BAR Meeting  
March 25, 2009

**ISSUE:** Addition and Alterations  
**APPLICANT:** Mo Movahed by Andrew Schiefer  
**LOCATION:** 426 North Alfred Street  
**ZONE:** RB/Residential

**BAR CASE #2009-0012, 0013 3/25/2009**

Figure 5. Existing conditions of east and west elevations.

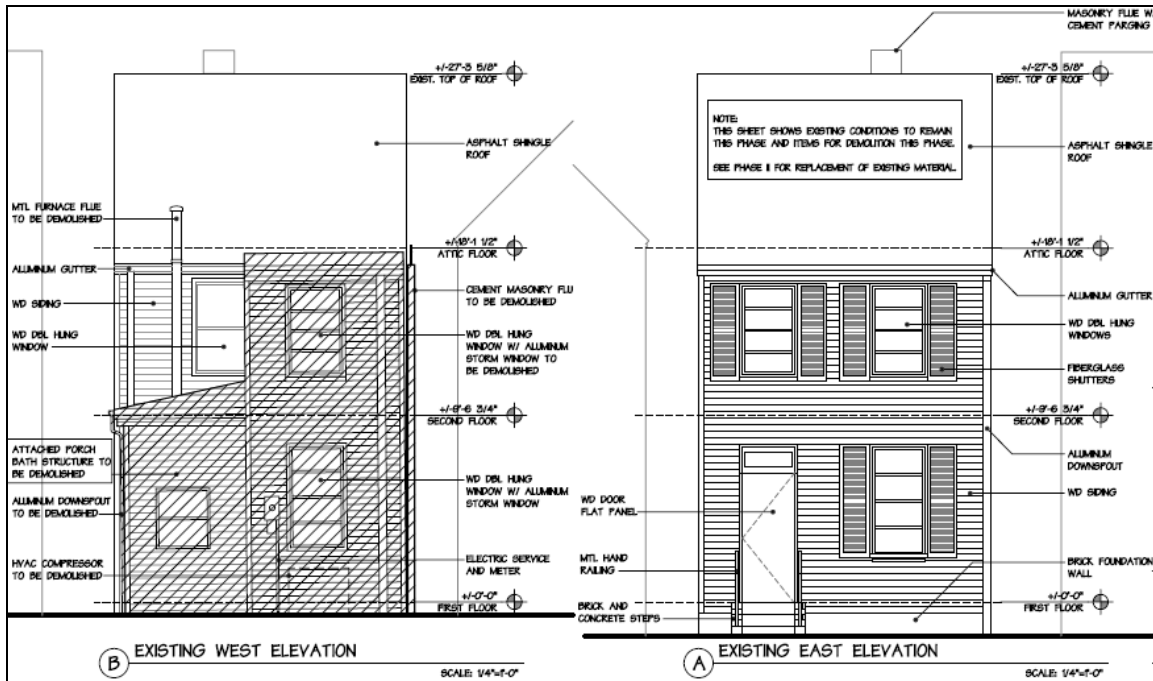
Staff is concerned about the proposed addition of dormers on the front elevation as it will significantly alter the principal elevation of this historic building. The front elevation retains a strong sense of integrity lacking in other elevations of the building, which have been altered and added on to over the years, and so should be sensitively retained and restored. While the Board indicated that one or two dormers may be appropriate on the front, Staff recommends that a single dormer is most appropriate and compatible with the historic architecture.

1. That only one dormer be added to the front elevation of the historic house.
2. That the applicant restudy the proposed rear (west) elevation to make the second and third story porches more open and transparent and in keeping with a traditional porch vocabulary.
3. That the applicant provide specifications for the proposed railing on the rear elevation for approval by Staff.
4. That the replacement modillions for the front cornice be made of wood and that the detailed profile be approved by Staff.
5. That the proposed front door be wood, painted or stained, and be approved by Staff.
6. That all proposed light fixtures be approved by Staff prior to installation.
7. That the proposed fiber cement siding be smooth (not simulated wood grain) and that the nails not show in the installation of the siding.

Figure 13. Section of proposed addition and alterations.

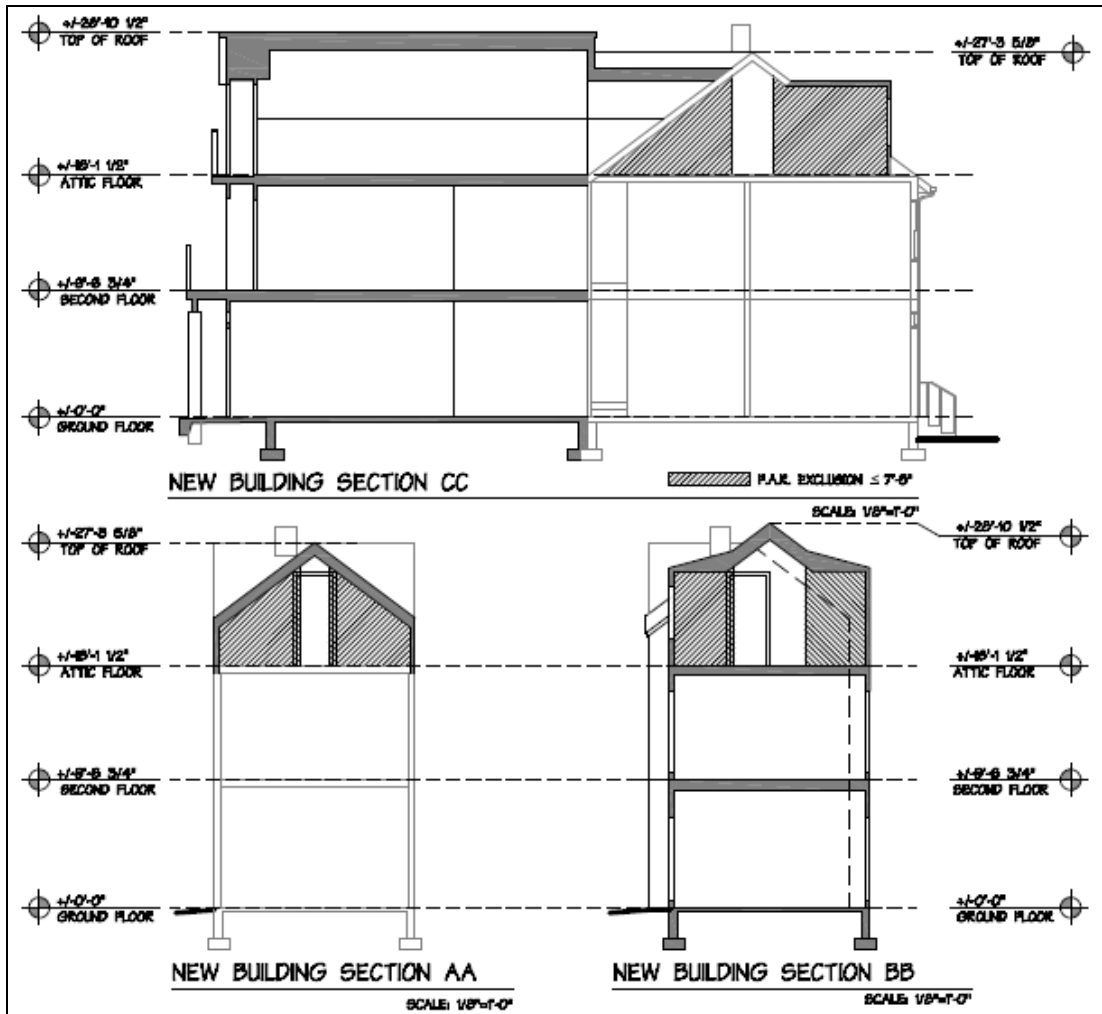
balcony above. The second story will have a center single-light door leading to the balcony, flanked by wood windows. The third story will have a single door leading out to a balcony with projecting arched rail. The balconies on the second and third stories are proposed to be almost entirely enclosed and clad in cementitious siding.
